The Point Mission Bay

Comments

4. Arrow points to hatched area of ground to not be raised next to [redacted] Rukutai St per Environment Court document

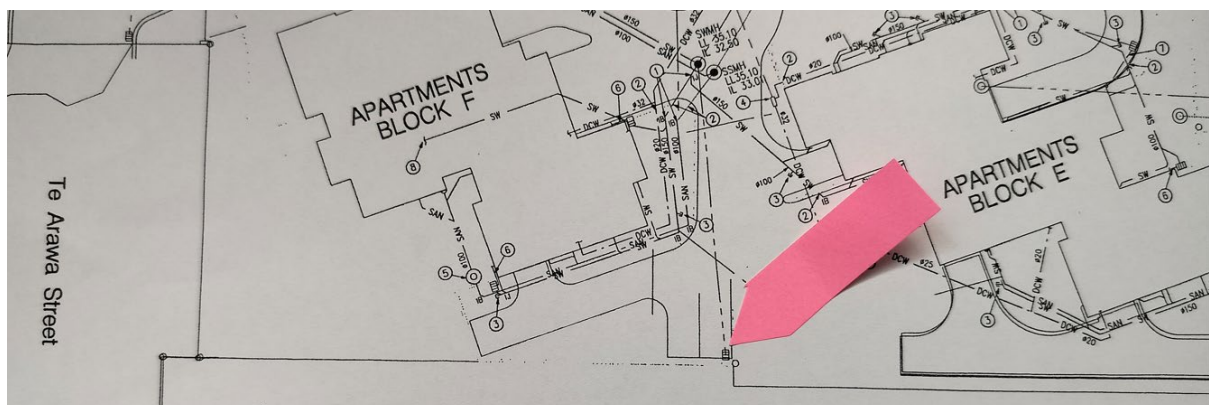
The existing ground levels on the area of the site shown shaded on Drawing 05 Rev A on the attached plans shall not be raised.

The plan below identifies the area of land which “shall not be raised” on [REDACTED] Rukutai Street.

9. Water with unknown substance running down northern side of [REDACTED]

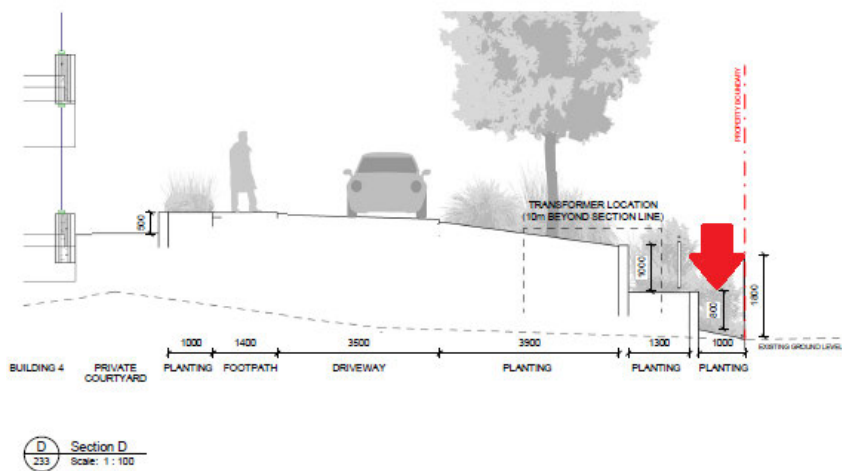
However, during July to September 2025 the drain (Figure 6) on the development property just north of the western boundary of 106 Rukutai St was in fact demolished and changed into what appears to be a soak hole. This resulted in seepage onto the property of [REDACTED]. This seepage did not occur previously. This has now made lawn maintenance difficult and created a wet area on the north-west corner of [REDACTED] close to where the drain was dismantled.

Photos below show significant water influx into the lawns on [REDACTED] after the drainage was changed.
